**SITE PLAN**  
**Bachmann/Stup Residence**  
**Addition**

13780 Burntwoods Road  
 Glenelg, Maryland 21737

Re: Septic and well at 13780 Burntwoods Road, Gleneig, Md.

SITE PLAN

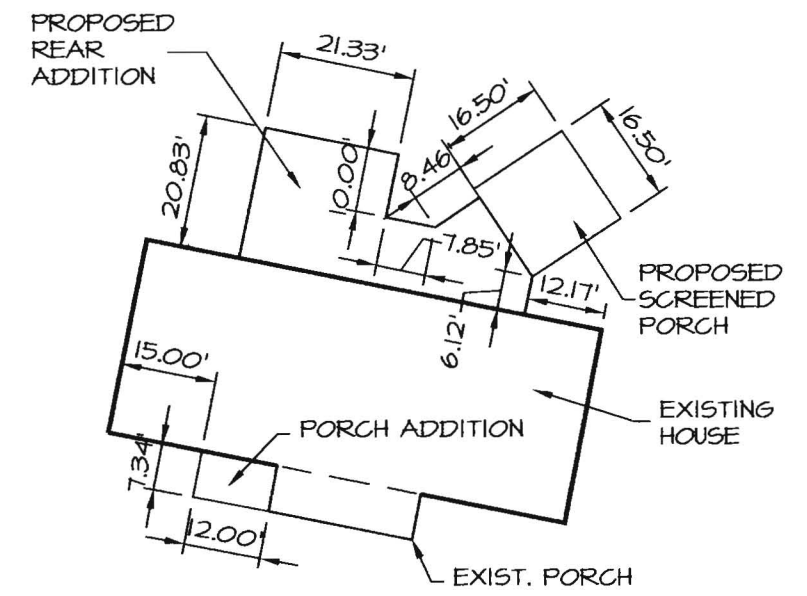
As you can see on the drawing, the proposed addition in the back of the house does not intrude into the 20 foot offset of the septic field but the proposed screened porch does. Can this be approved? The floor of the screened porch will most probably be a concrete slab. If any adjustments need to be made to the septic area, now is the time to do it.

Also, in the front of the house, the existing concrete front porch already intrudes into the 30 foot offset for the well. We are proposing to add an entrance to the house as shown and extend that front porch as shown. All of these things are within the 30 foot offset. If a new well is required, we would like to know so that it may be negotiated with the seller now.

5/02 - Telephone conversation w/ Ms. Stup -  
System will be sized for a 5 bedroom house.  
Well & Septic Setbacks to all proposed additions will be OK.  
Screened porch can be less than 20' to SDA  
since it is not on a foundation.
